PROPOSED CHANGE NOTICE

2445-29

RE: AURORA FOOD STORE
2000 ANAQUOD ROAD
REGINA, SK
Commission No. 2445

RE: Security Layout Revisions

SHEET TITLE:
FLOOR PLAN - SECURITY
COMMISSION NUMBER:
2445
SHEET NUMBER:
E6.0

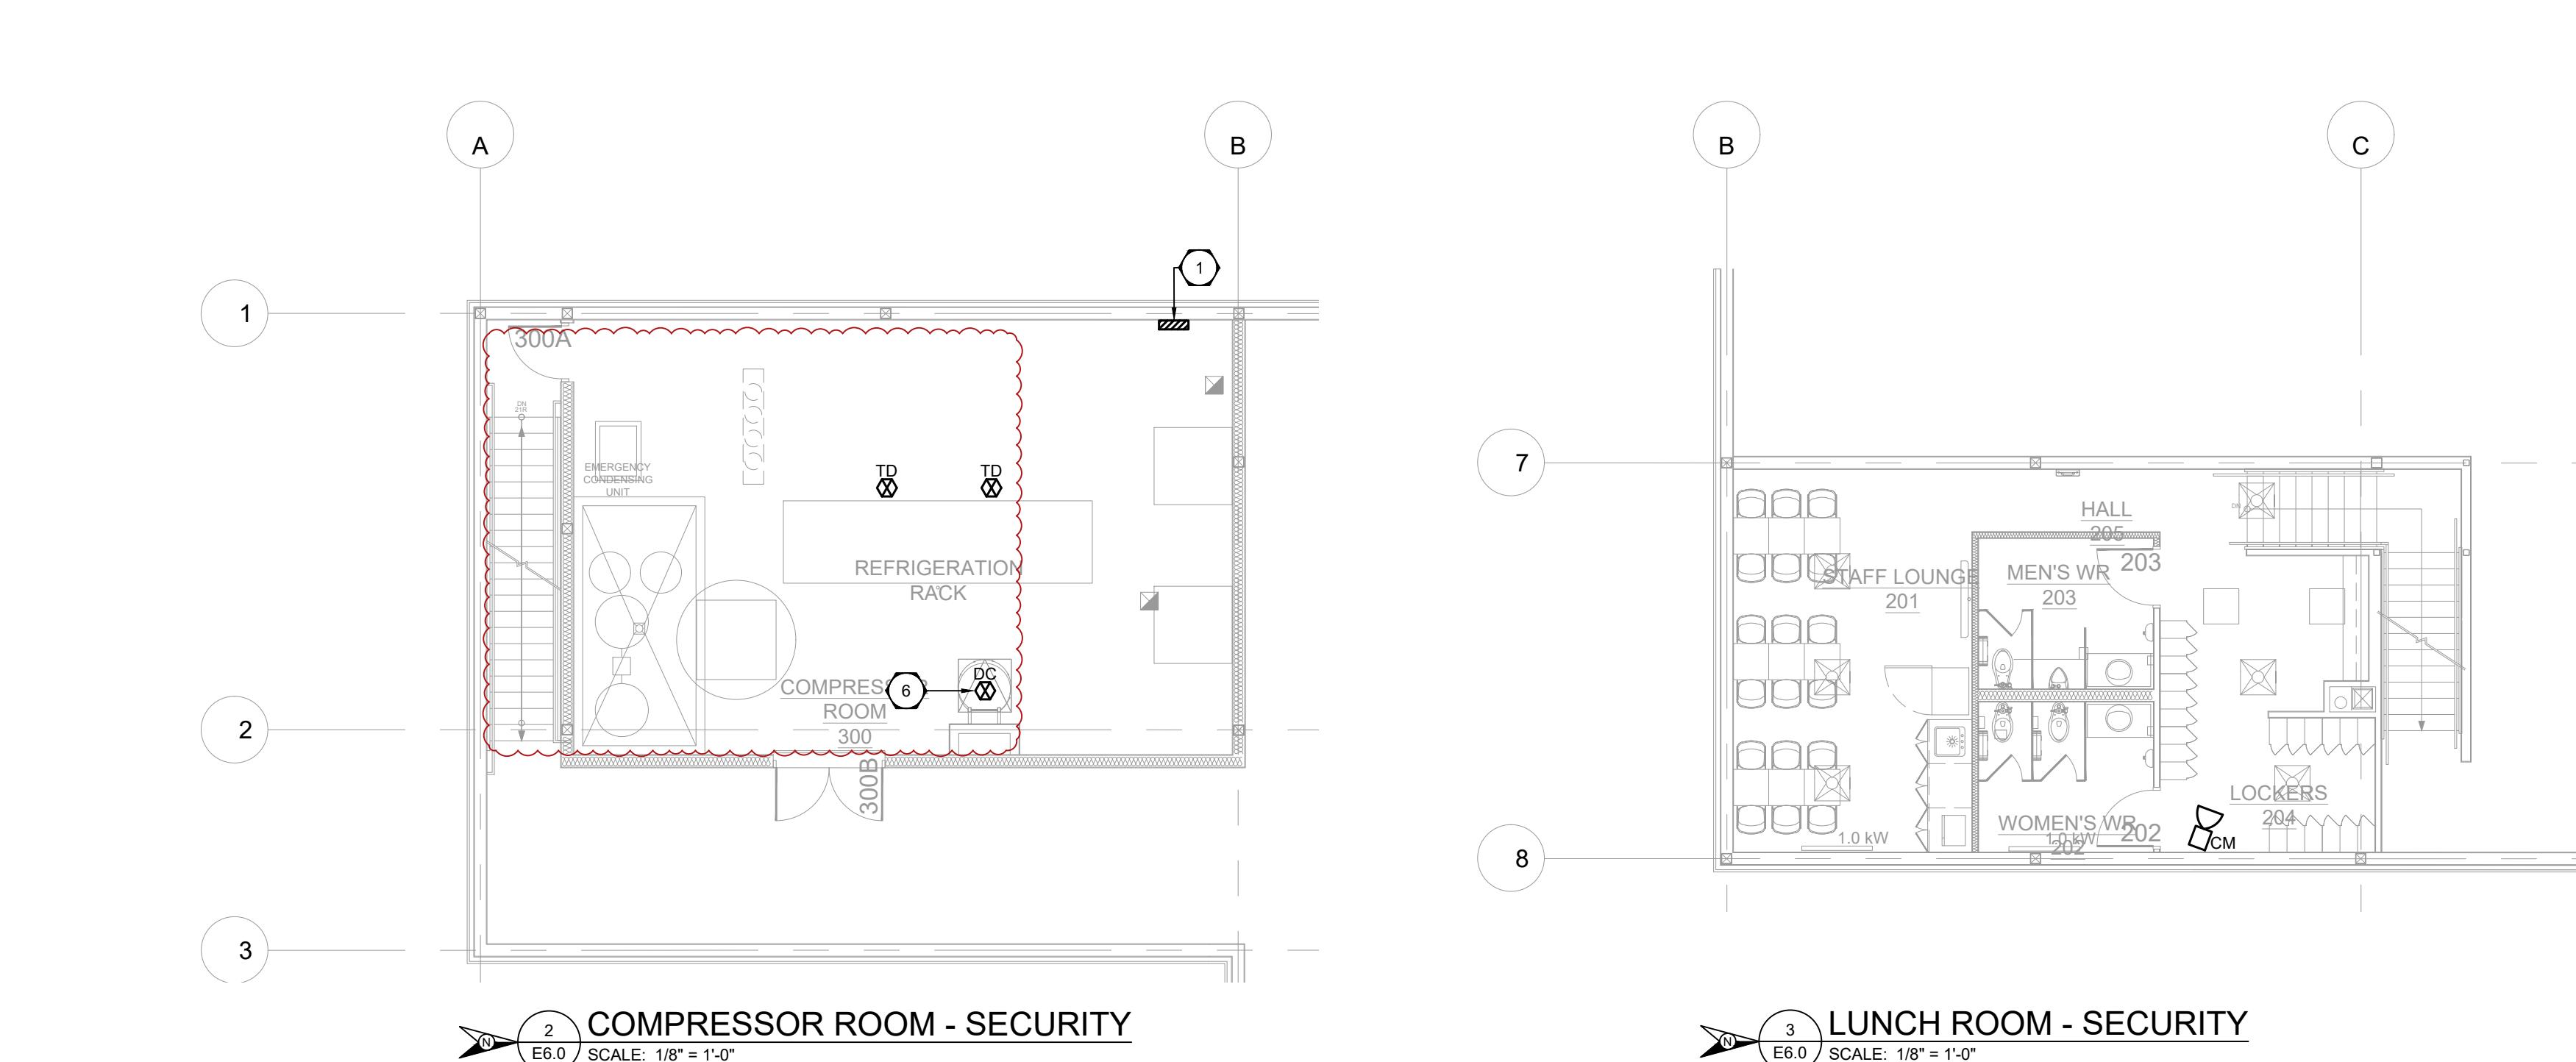
1. Refer to attached drawing E6.0 for revisions to the security system design and rough-in requirements for the security system. Confirm exact requirements with Sobey's security system representative on site prior to rough-in. **Provide a credit to the owner's for security scope that has been removed from the project as shown on drawing E6.0.** See below for itemized list of changes:

- 1.1. Access-Secured Door:
 - 1.1.1. Deleted from doors #190B, #190C.
 - 1.1.2. Added to interior side of door #190A.
 - 1.1.3. Deleted from impact doors #119A, #119D.

- 1.1.4. Deleted from interior vestibule door #110C.
 - 1.1.5. Added to interior side of door #104.
 - 1.1.6. Added to door #110.
 - 1.2. Key-pad:
 - 1.2.1. Added to doors #190A, #140D and #104.

- 1.3. Piezo Electric Alarm:
 - 1.3.1. Deleted from doors #191A, #191B, #119B.
 - 1.4. Security Panel:
 - 1.4.1. Added one(1) keynote #1 Security panel in 'IT Room 114'.

- 1.5. Security System Siren / Strobe:
 - 1.5.1. Added to doors #191A, #191B and #119B.
 - 1.6. Electric Strike:
 - 1.6.1. Added to door #110.
 - 1.7. Door Contact:

- 1.7.1. Added to doors #141A, #140D, and #110.
 - 1.7.2. Added to roof access hatch in 'Compressor Room 300'.

- 1.8. Motion Sensor:
 - 1.8.1. Added to "Receiving 190", 'Pharmacy Prep 140', 'Cash Office 116', "Seating 101", 'Vestibule 100'.
- 1.9. Glass Break Sensors:

- 1.9.1. Added four(4) to 'Checkouts 104' and one(1) to 'Seating 101'.
- 1.10. Temperature Detector:
 - 1.10.1. Added two(2) to 'Compressor Room 300'.
- 1.11. Security System Siren Only

- 1.11.1. Added to door #110.
2. Refer to attached drawing E0.0 for additional symbols related to the security system.
3. Refer to attached drawing E0.2 for one(1) additional 20A-1P circuit to serve the security equipment panel and access controller point.

4. Keynote #1 on drawing E6.0 is revised to read the following:
 - 4.1. 'PROPOSED LOCATION OF SECURITY EQUIPMENT PANEL AND ACCESS CONTROLLER POINT. PROVIDE ALL NECESSARY CONDUITS USING 3/4" DIAMETER MINIMUM. PROVIDE ONE(1) 120V DUPLEX RECEPTACLE AND ONE(1) DATA. COORDINATE WITH SECURITY SYSTEM CONTRACTOR PRIOR TO ROUGH-IN.'

5. Keynote #6 on drawing E6.0 is revised to read the following, now related to the 'Compressor Room 300' roof access hatch:
 - 5.1. 'DOOR CONTACT FOR SERVICE ROOF ACCESS HATCH. CONFIRM EXACT REQUIREMENTS AND FINAL LOCATION WITH SOBEYS SECURITY REPRESENTATIVE.'

6. Keynote #9 on drawing E6.0 is revised to read the following, now related to the door contacts for the 'Receiving 190' overhead doors:
 - 6.1. 'DOOR CONTACT SERVING OVERHEAD DOORS. CONFIRM EXACT REQUIREMENTS AND FINAL LOCATION WITH SOBEYS SECURITY REPRESENTATIVE.'

7. General note #2 is added to drawing E6.0 and reads the following:
 - 7.1. 'ALL SECURITY SYSTEM WIRING IS TO BE RUN IN CONDUIT AND BE CONCEALED. SURFACE MOUNT CONDUIT FOR SECURITY SYSTEMS IS ACCEPTABLE IN 'WAREHOUSE 191', 'RECEIVING 190' AND 'COMPRESSOR ROOM 300.'
